The Proposed Dry Wash Reservoir: Size and Shape

Prepared by Wayne D Pennington
for the Ivins City Council meeting of March 21, 2021

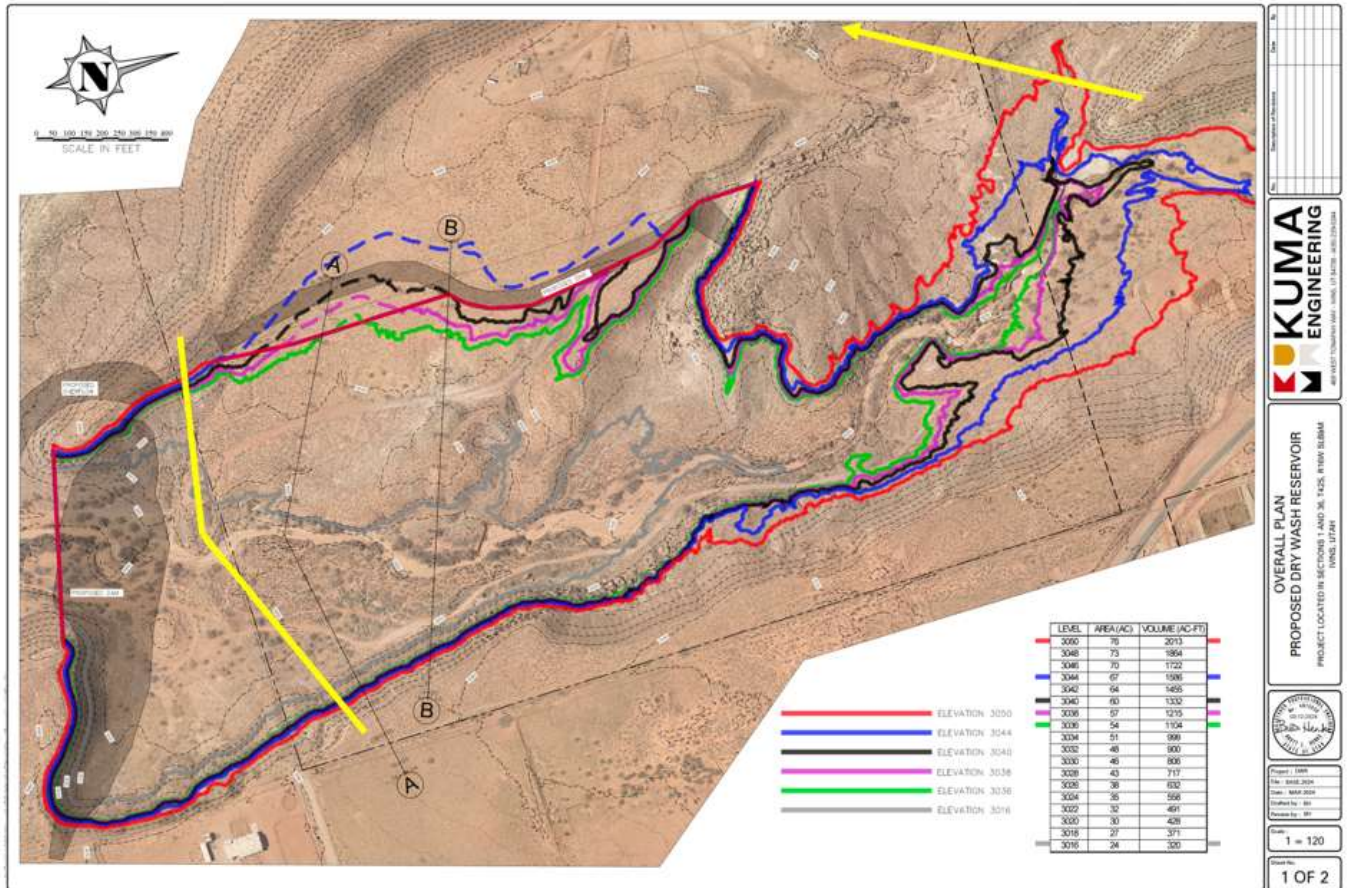
The Geotech Study clearly identified 3,040 ft elevation (black line in Figure1) as the maximum height for a reservoir with a dam at this Dry Wash location, saying (p.17) “it is our opinion that the **high water level should not extend above elevation 3040 feet.**” It also states (p. iv) “Efficient storage with a dam at this location is **limited to about 1300 acre feet due to the competent bedrock elevation.**” In Chapter 5 (p.21), the Geotech Study emphasizes: “it is our opinion that the high water level **should not extend above elevation 3040 feet. This results in a maximum storage capacity of about 1300 acre feet...**” This conclusion is based on the poor quality of rock (soil) above 3,040 ft in the formations

The EA also specified a **high-water level of 3,040 ft**. Additionally, the EA calculated a **capacity of 1335 acre-ft** of water, and an inundated **surface area of 63 acres** (p. 11 Appendix C). These values are all internally consistent, and verified to be consistent by modern mapping methods (see the table inserted in Figure 1 for confirmation).

The 2004 Geotech Study considered a number of locations for the dam site. The only location that would yield a capacity greater than 1335 acre-ft is further upstream, together with a large dike, as shown by the yellow lines in Figure 1. This configuration was implicitly rejected by the EA, which considered and specified a dam at the location shown by shading in Figure 1. [Any claims that the EA or other environmental studies allowed a larger reservoir are apparently conflating the studies done for alternate, upstream, dam locations with the one that was finally accepted by the EA.]

For the WCWCD-proposed high-water level reservoir at 3,044 ft, the area exposed to drying out is 43 acres. [The difference between this value and my earlier figure of 47 acres is the area excluded by the presence of the dike in the current assumption.] The area exposed at low-water level by a reservoir with 3,040 ft high-water level covers a surface area of 36 acres; incrementally lower high-water levels progressively decrease the size of the exposed area. We should note that the WCWCD is planning to excavate some of the basin (reservoir bottom) to help increase capacity and to provide material for construction of the dam and dike; if additional material can be excavated and strategically placed along the shoreline, capacity can be increased while decreasing the surface area, a desirable consequence from all points of view, and one that the WCWCD has expressed interest in.

Figure 2: Two cross-sections A-A and B-B identified on the map in Figure 1 by faint lines crossing the reservoir. Note the broad, shallow western flank of the reservoir, and the modest reduction in area submerged as high-water level is decreased. Vertical exaggeration is 2:1.

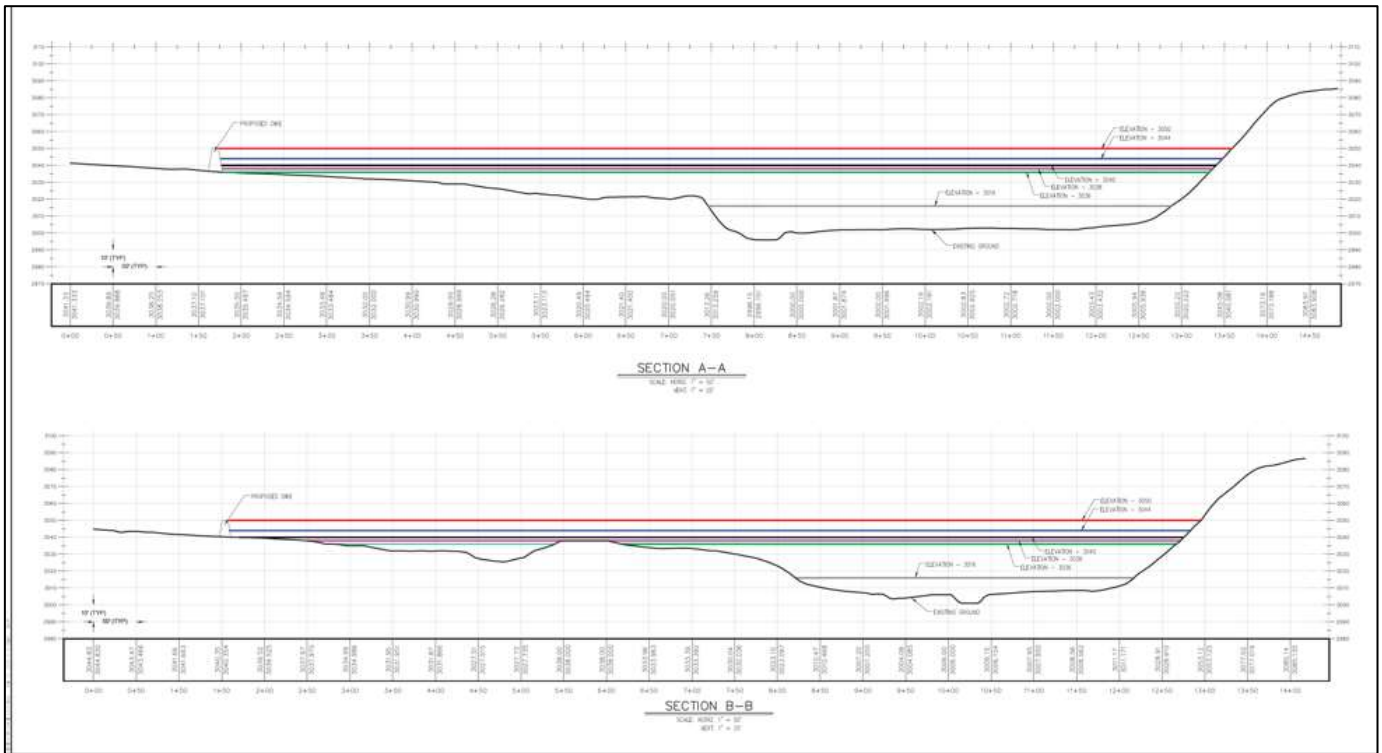
The problem of subaerial exposure is concentrated on the western side of the reservoir, as can be seen in Figure 1 and in the cross-sections shown in Figure 2.

What this means is that the smaller alternately exposed areas near the upstream end of the reservoir will not result in much airborne dust, due to their shorter lengths and enclosure by steeper walls. But the broad, shallow flank on the western side of the reservoir will, for nearly any wind direction, present a hazard due to windborne particles if the fetch is long enough. One of our objectives in reservoir design should be to minimize the fetch, the distance along which wind can produce saltation and pick up material.

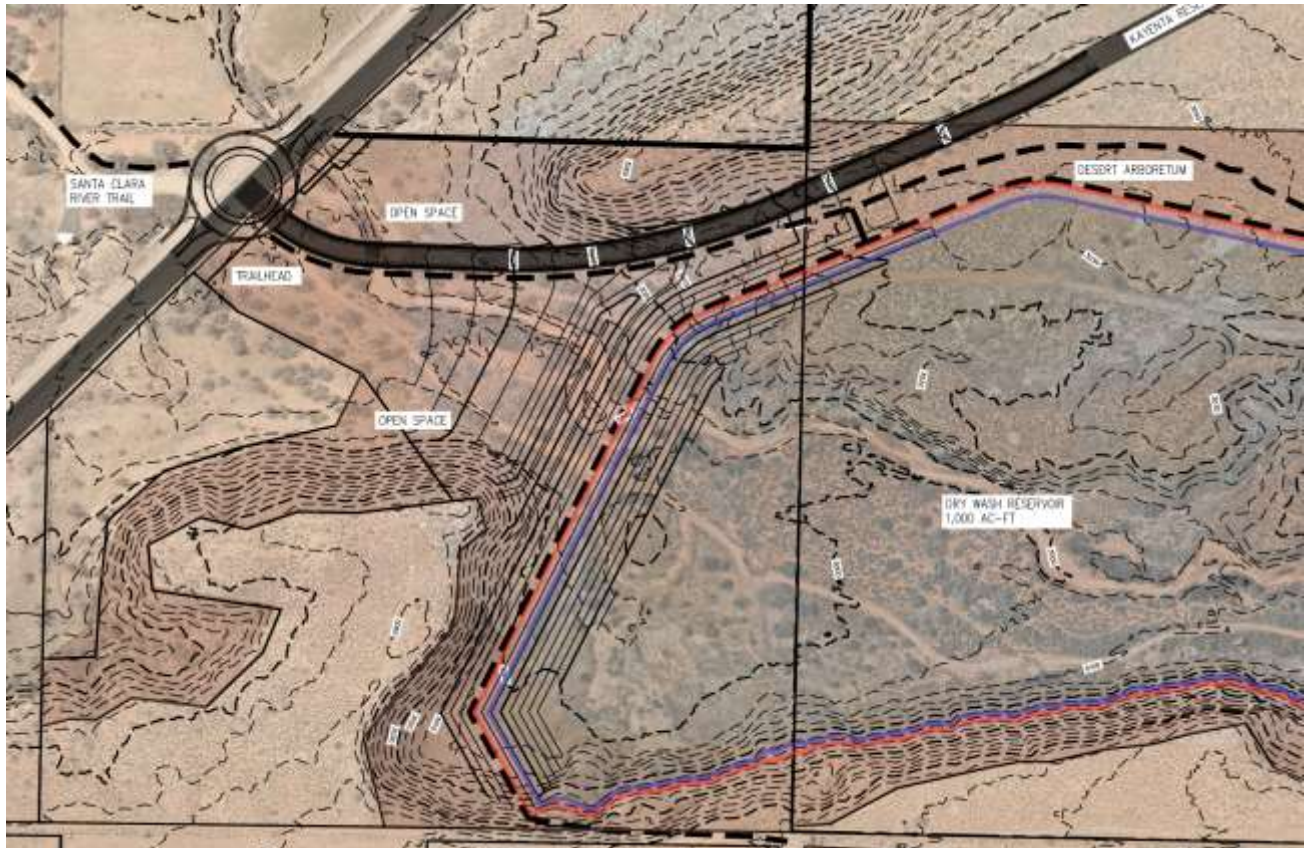
A recent proposal provided by Terry Marten, is presented here. Figure 4 shows a closeup of the dam area itself, and Figure 5 shows a larger overview of the reservoir area.

This reduction in alternately exposed and submerged areas, or length of fetch, can be accomplished in a few ways, but the most beneficial for Dry Wash would be to move the dike further toward the center of the reservoir, while reducing the high-water level to some lower level, in the meantime excavating the material from the western floor of the reservoir and placing it landward of the dike. [This was the basis for my earlier proposal for a high-water level of 3,038 ft, leading to a capacity of 1215 acre-ft before excavation; this would help, but not completely mitigate the issue.]

The placement of the excavated material can be arranged to maximize some benefit, such as raising the level of residential lots behind the dike so that they are less likely to be subject to ill effects from rising water tables caused by the reservoir. Some could be placed immediately behind the dike to allow for a continuous trail along the waterfront. Some could be placed between the dam and Old Hwy 91 to create a berm that would hide the dam itself from view. Some could be used to establish barriers (or levees) that would break up the fetch across the exposed area.

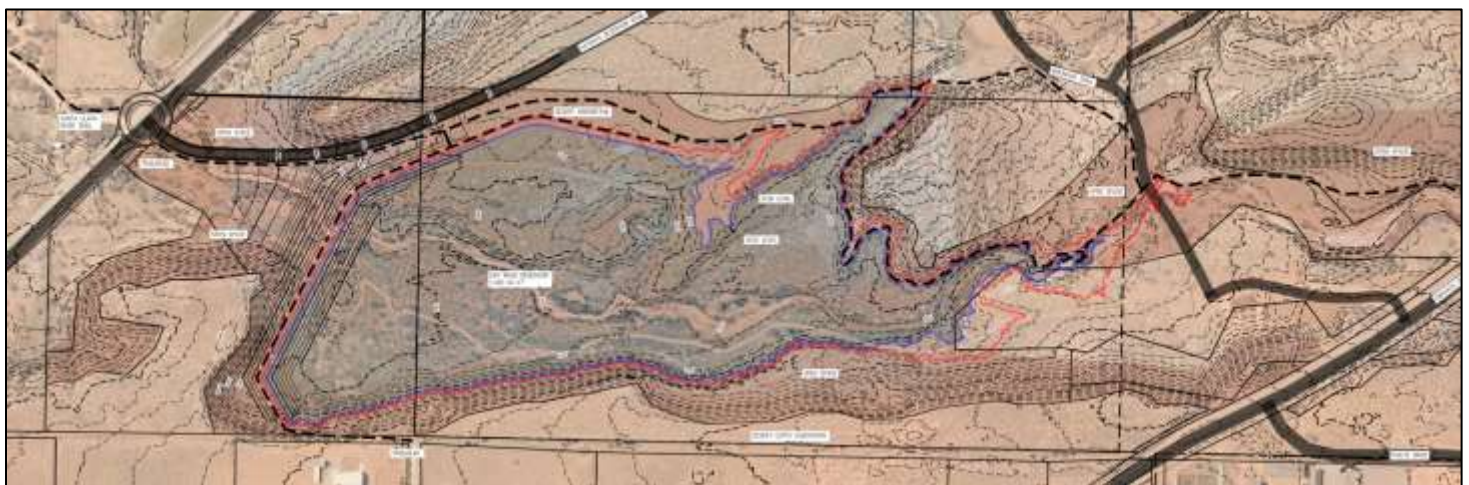
- The decreased high-water level and the greater distance between the reservoir and low-lying land to the west (top in the figures) greatly reduces, and perhaps eliminates, the risk to those homesites of ground-water encroachment. Likewise, the reduced high-water level reduces the additional hazard due to landslide potential for the lots on the ridge to the east (bottom in the figures).

- The threat of windblown dust carrying material that has precipitated from the reuse water is minimized by shortening the distance along which wind may pick up material. Careful engineering and landscape design would be instrumental in accomplishing this.
